Access Compliance Report

Public Rights-of-Way (Curb Ramps)

| Intersection ID: 50532 | Main Street: STRAUSE_DR | Cross Street: SAMLEN_LN | Location: SE |
| ADA ID: C4D83D427565 | Ramp Type: BlendTrans1 | Initial Pass/Fail: Fail | Overall Compliance: No |

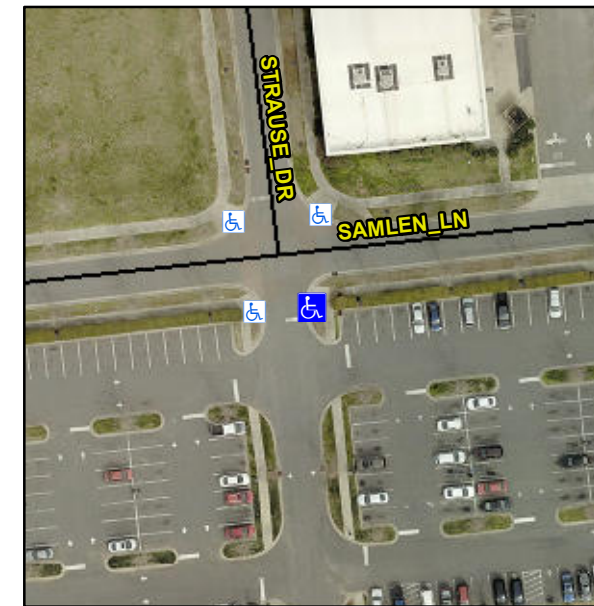
Not Found, R304.5.1

| Compliance | Description | Data | Compliance | Description | Data |
|------------|-----------------------|-------|------------|-----------------------------|-------|
| No | Ramp Width (in) | 47.0 | Yes | BlendTrans XSlope (%) | 1.0 |
| | | | No | Curb Slope (%) | 8.4 |

Remove & Replace Curb Ramp With Two New Directional Ramps or Equivalent.
